PROJECT NAME: MINOR SITE PLAN FOR DAN WILSON

PROJECT NUMBER: 2023110014

APPLICATION: MINOR SITE PLAN #30825

REVIEW ITEM: Minor Site Plan

SITE PLAN
MINOR SITE PLAN
DAN WILSON
MARION COUNTY, FLORIDA

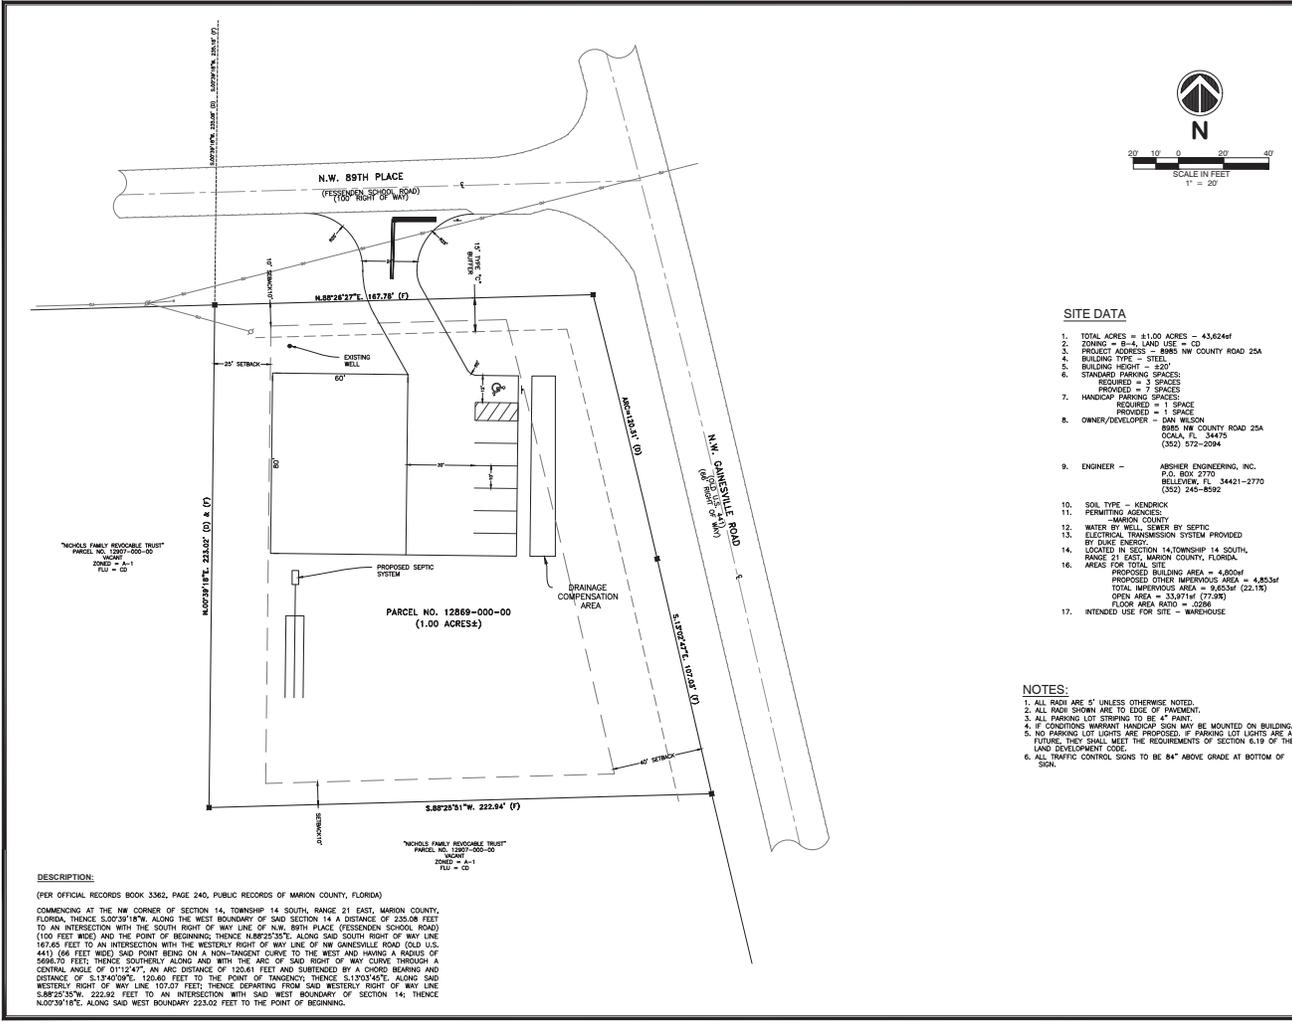
- 13 DEPARTMENT: ENGTRF - TRAFFIC REVIEW
REVIEW ITEM: 6.11.4.B - Cross access
STATUS OF REVIEW: NO
REMARKS: 11/19/23 - A 24' wide paved cross access easement is required along NW Gainesville Road. Show the easement on the plans and pave it to the southern property line. The easement shall be recorded prior to final plan approval. Please contact Cheryl Weaver in the right-of-way office for the required standard easement template and to coordinate the recording of the easement.

- 14 DEPARTMENT: ENGTRF - TRAFFIC REVIEW
REVIEW ITEM: 6.11.5 - Driveway access
STATUS OF REVIEW: NO
REMARKS: 11/19/23 - The driveway needs to be located next to the western property line to maximize spacing from NW Gainesville Road.

- 15 DEPARTMENT: ENGTRF - TRAFFIC REVIEW
REVIEW ITEM: 6.11.9.C - Pavement marking
STATUS OF REVIEW: NO
REMARKS: 11/19/23 - Show the width of the parking spacings and the length and width of the handicap aisle.

- 17 DEPARTMENT: ENGTRF - TRAFFIC REVIEW
REVIEW ITEM: 6.12.12 - Sidewalks
STATUS OF REVIEW: NO
REMARKS: 11/19/23 - 1. Sidewalk is required along NW Gainesville Road with access onto the site. 2. An accessible route needs to be provided from the handicap spot to the building entrance including sidewalk.

- 18 DEPARTMENT: 911 - 911 MANAGEMENT
REVIEW ITEM: Additional 911 comments
STATUS OF REVIEW: NO
REMARKS: Sheet 02 has incorrect Project Address of 8985 NW County Rd 25A listed in Site Data. It should be TBD.
